PCI-SIG ENGINEERING CHANGE NOTICE

TITLE:	CLKREQ# dynamic protocol
DATE:	February 01, 2004
AFFECTED DOCUMENT:	PCI Express Mini Card, Release 1.0
SPONSOR:	Brad Saunders, Intel Corporation

Figure 3-1: Power-Up CLKREQ# Timing

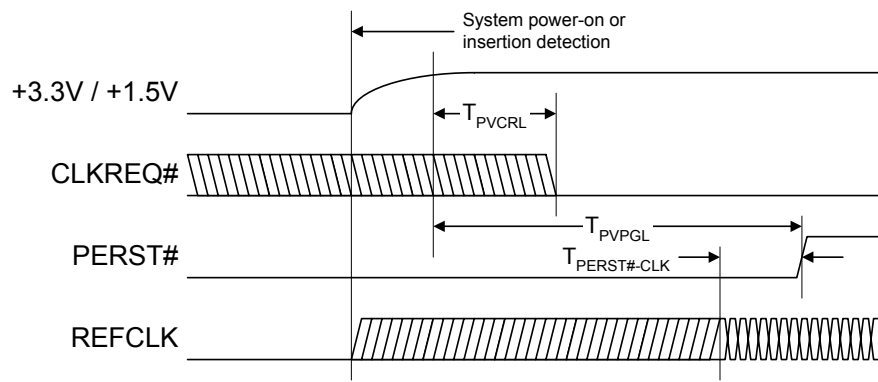
CLKREQ# is asserted in response to PERST# assertion. On power up, CLKREQ# must be asserted by a PCI Express device within a delay (T_{PVCRL}) from the power rails achieving specified operating limits and PERST# assertion. This delay is to allow adequate time for the power to stabilize on the card and certain system functions to start prior to the card starting up. CLKREQ# may not be de-asserted while PERST# is asserted.

The system is required to have the reference clock for a PCI Express device in the parked clock state prior to device power-up. The state of the reference clock is undefined during device power-up, but it must be in the active clock state for a setup time T_{PERST#-CLK} prior to PERST# de-assertion.

Figure 3-2: CLKREQ# Clock Control Timings

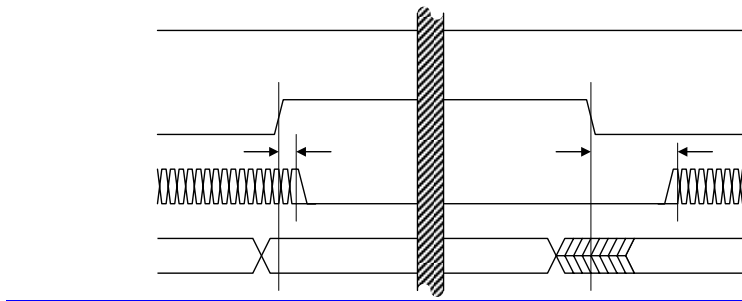
After a PCI Express device has powered up and whenever its upstream link enters the L1 link state, it shall allow its reference clock to be turned off (put into the parked clock state). To accomplish this, the device de-asserts CLKREQ# (high) and it must allow that the reference clock will transition to the parked clock state within a delay (T_{CRloff}).

To exit L1, the device must assert CLKREQ# (low) to re-enable the reference clock. After the device asserts CLKREQ# (low) it must allow that the reference clock will continue to be in the parked clock state for a delay (T_{CRlon}) before transitioning to the active clock state. The time that it takes for the device to assert CLKREQ# and for the system to return the reference clock to the active clock state are serialized with respect to the remainder of L1 recovery. This time must be taken into account when the device is reporting its L1 exit latency.

All links attached to a PCI Express device must complete a transition to the *L1,Idle* state before the device can de-assert CLKREQ#. The device must assert CLKREQ# when it detects an electrical idle break on any receiver port. The device must assert CLKREQ# at the same time it breaks electrical idle on any of its transmitter ports in order to minimize *L1* exit latency.

There is no maximum specification for T_{CRHoff} and no minimum specification for T_{CRLon}. This means that the system is not required to implement reference clock parking or that the implementation may not always act on a device de-asserting CLKREQ#.
